ADDENDUM No. 1

RFP No. 26-29

Dexter Road Sidewalk and Stormwater Improvements

CONSTRUCTION PLAN - STA 6+50 TO STA 10+50

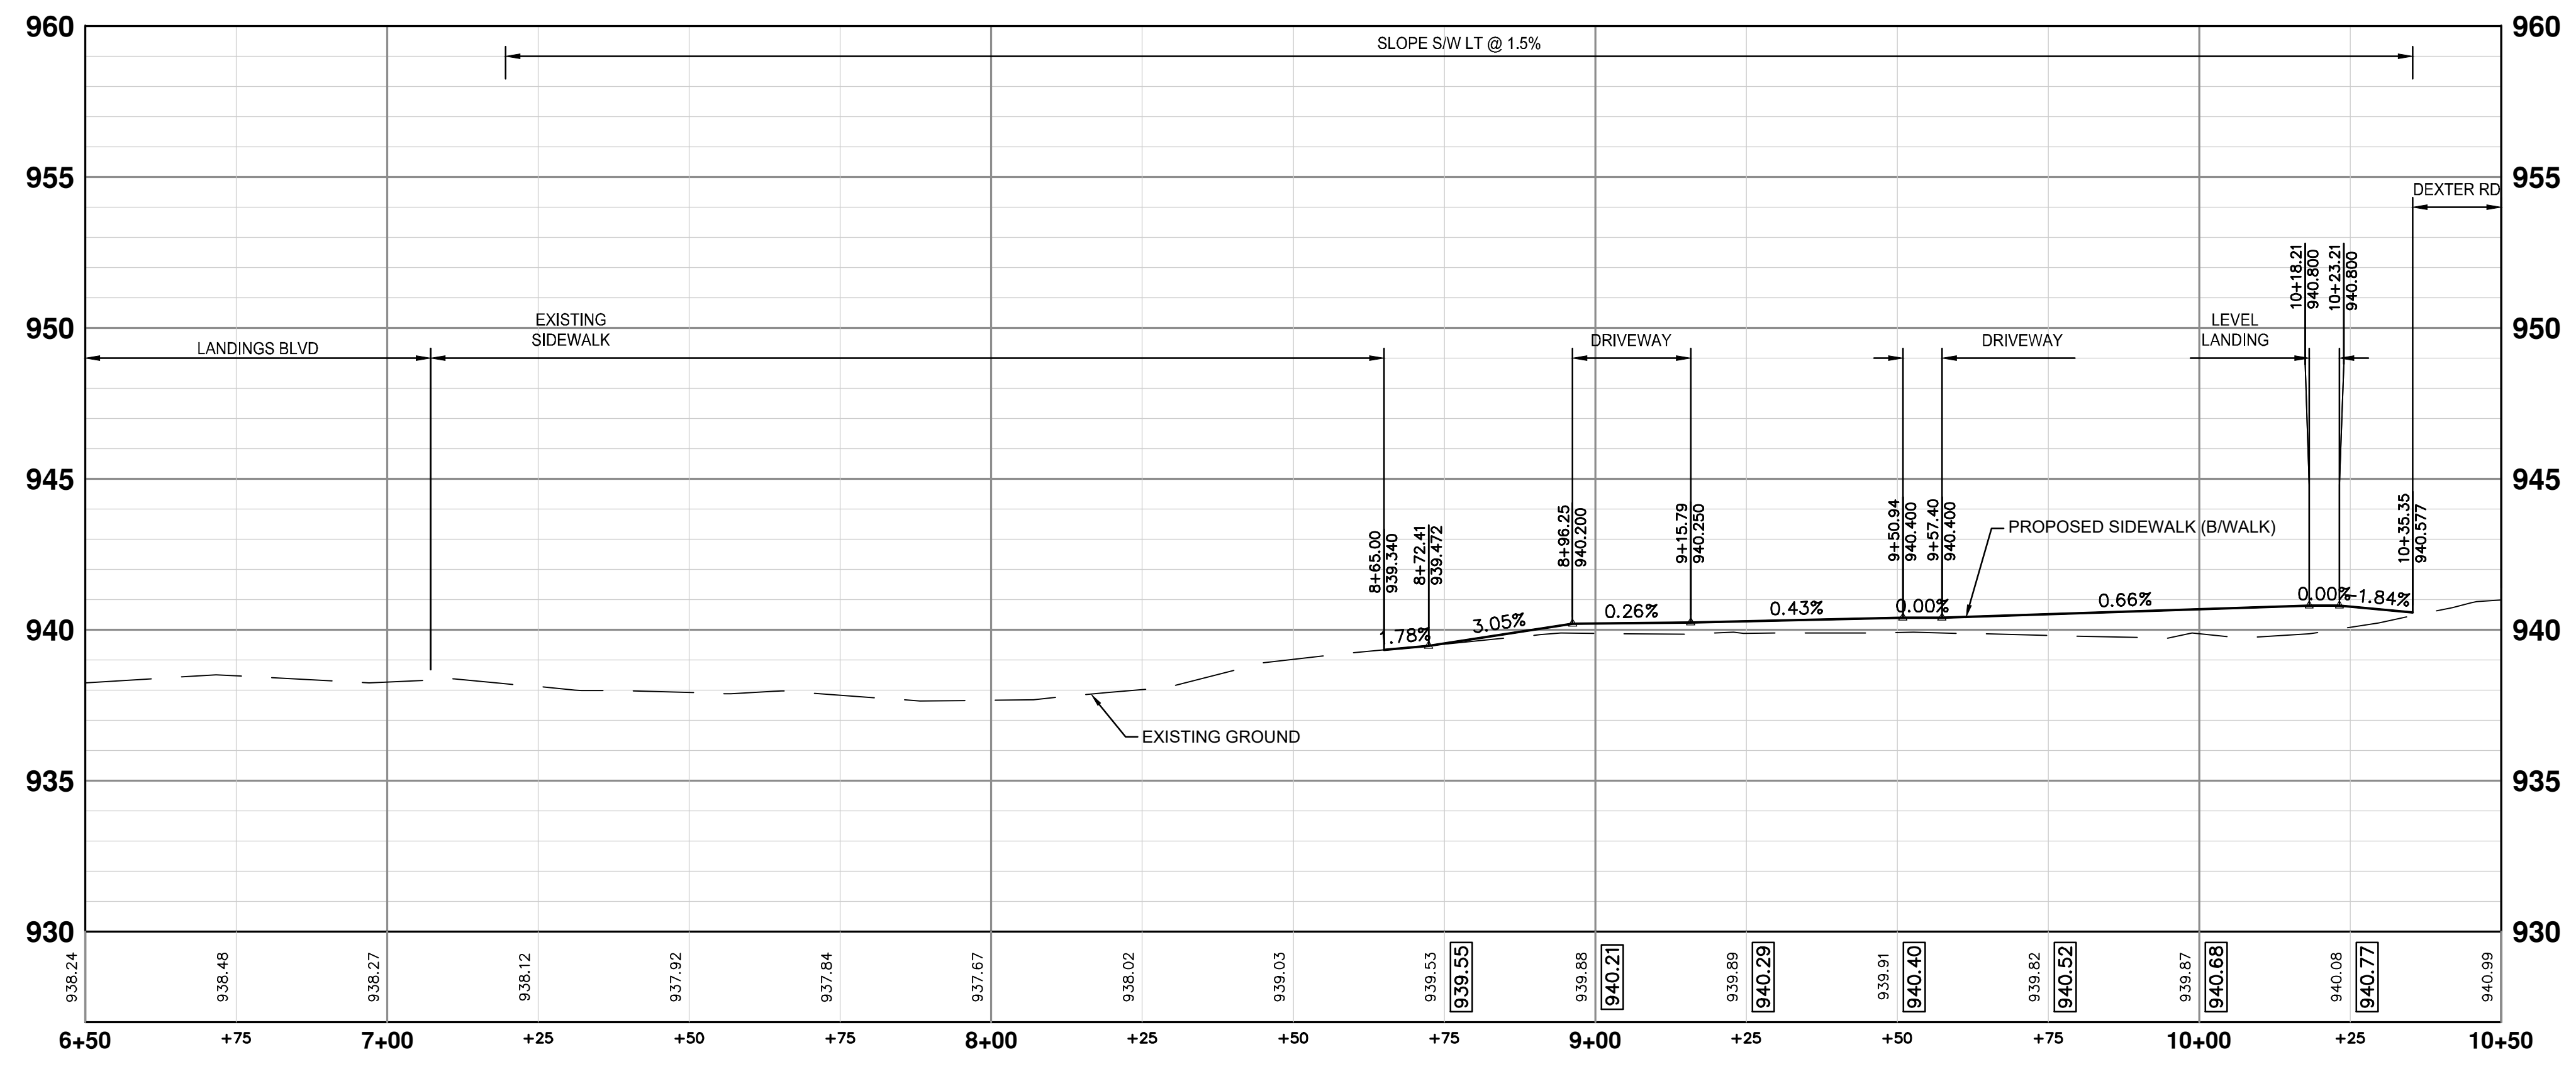
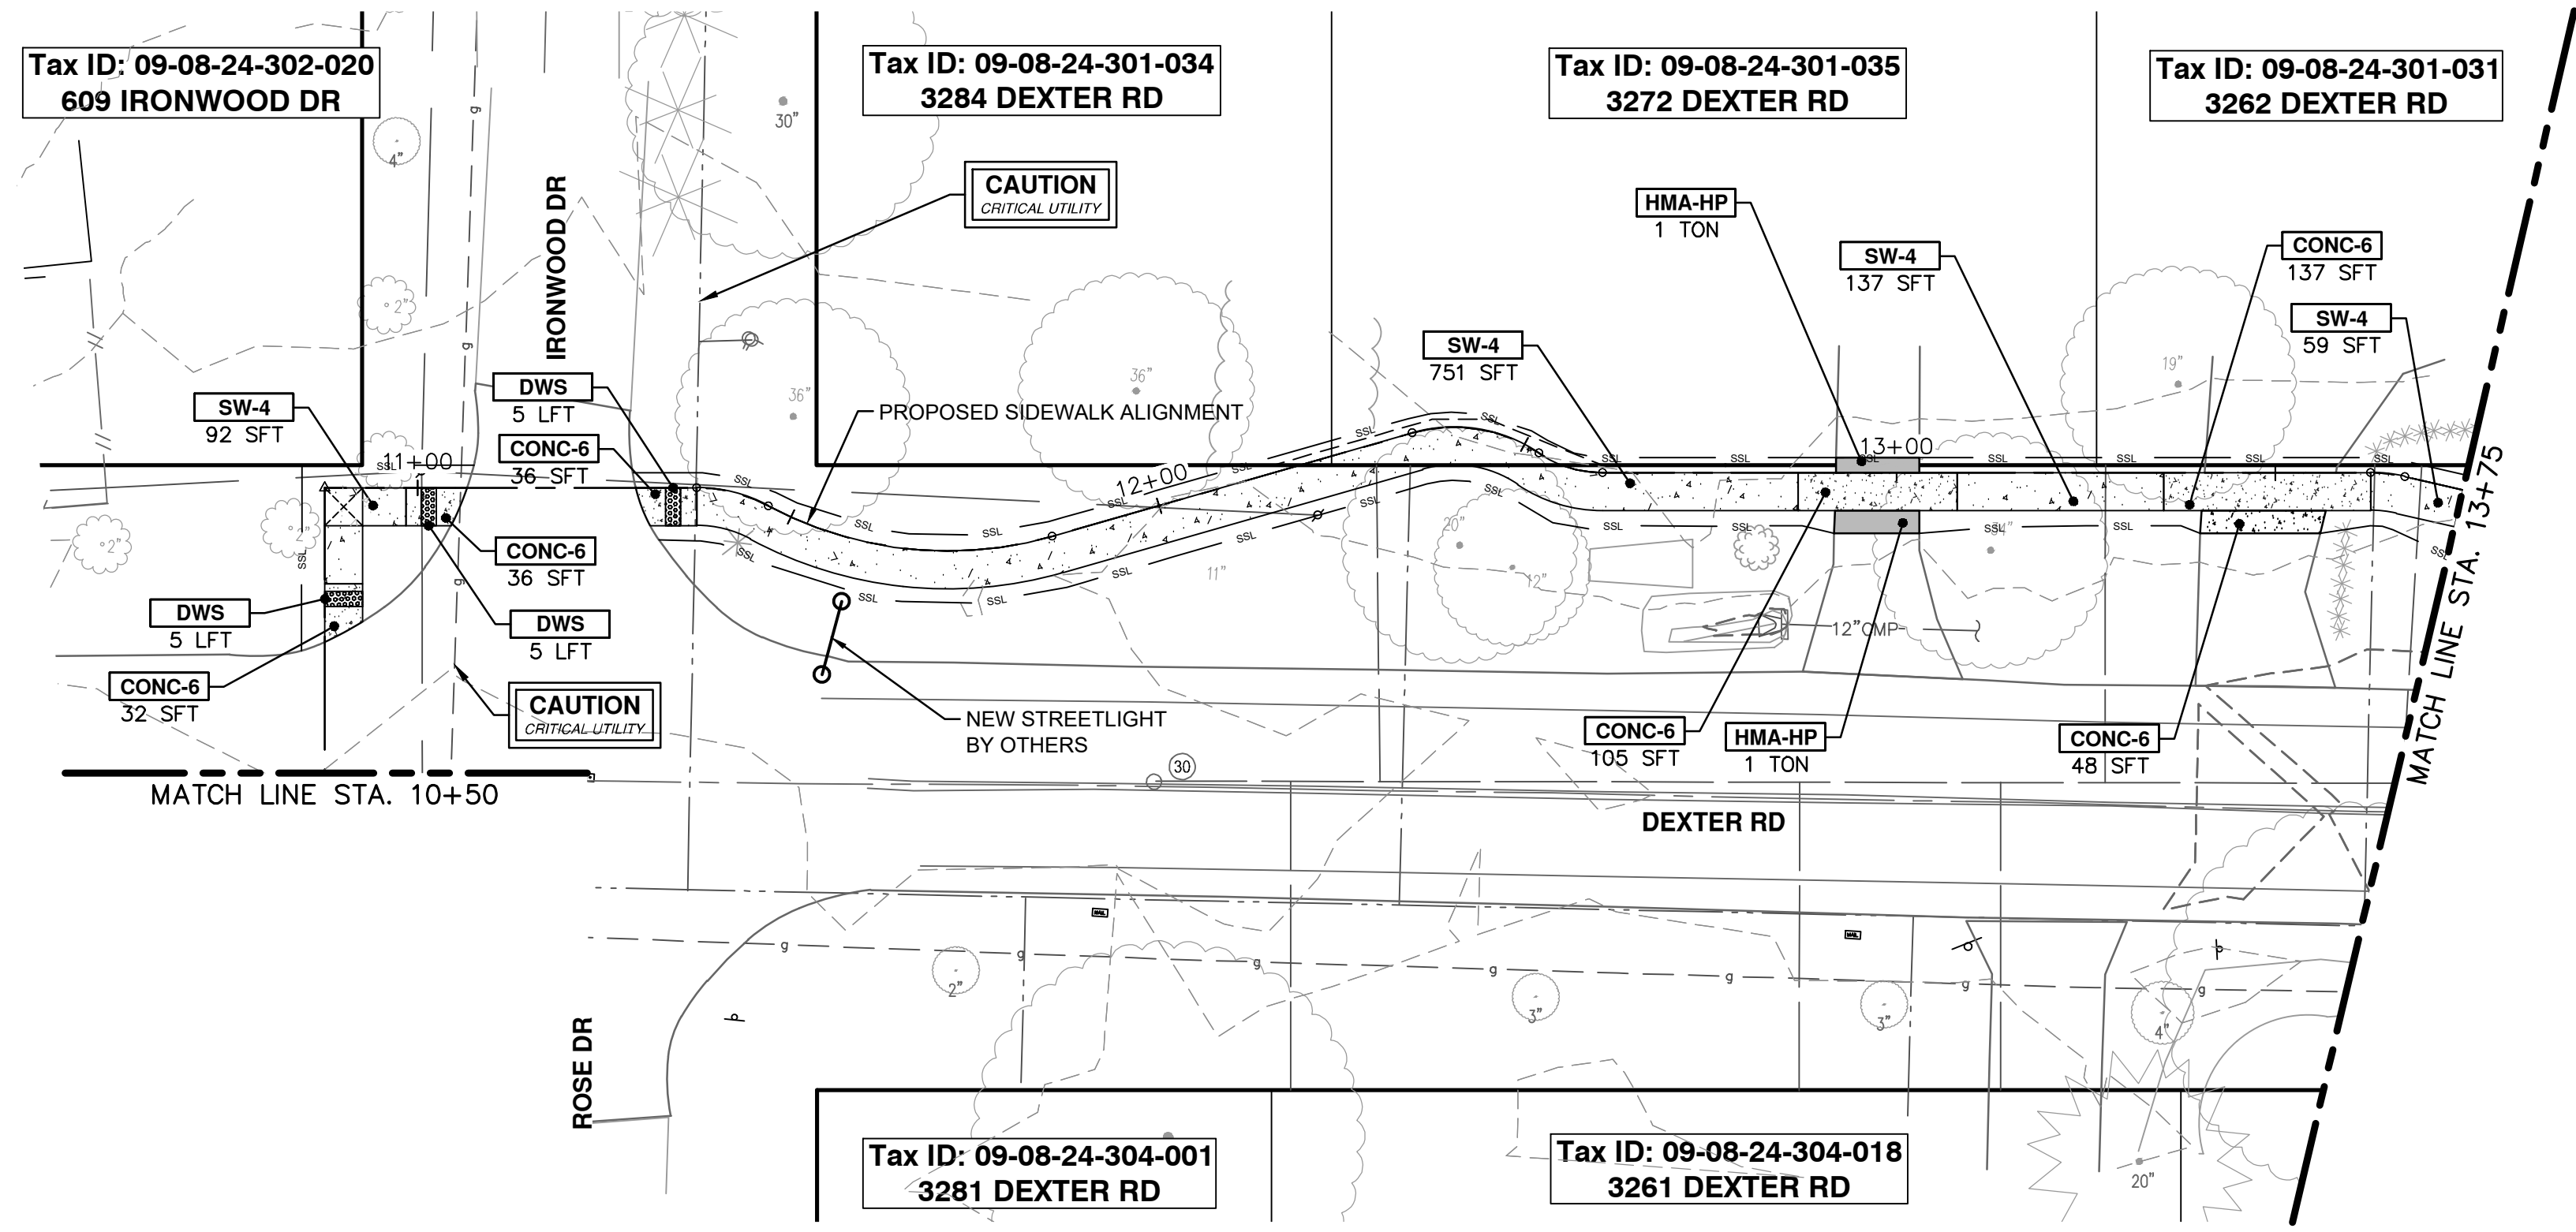
Plan Sheets 19 – 29	Updated plan and profile views to show proposed ditch grading work, added sidewalk retaining walls to profile view, extended sidewalk to Rose Drive (plan sheet 19), revised HMA replacement area for proposed crossroad culvert (plan sheet 28) added a CAUTION call-out notation to identify critical utilities, minor revisions to call-out notations/labeling, revised the "Construction Key" and the "Construction Quantities – This Sheet" table to reflect pay item updates.
Plan Sheet 30	Added a CAUTION call-out notation to identify critical utilities, minor revisions to call-out notations/labeling, and revised HMA removal/replacement area for proposed crossroad culvert.
Plan Sheets 31 – 32	Added proposed storm work, added pedestrian signal foundations, and minor revisions to call-out notations/labeling.
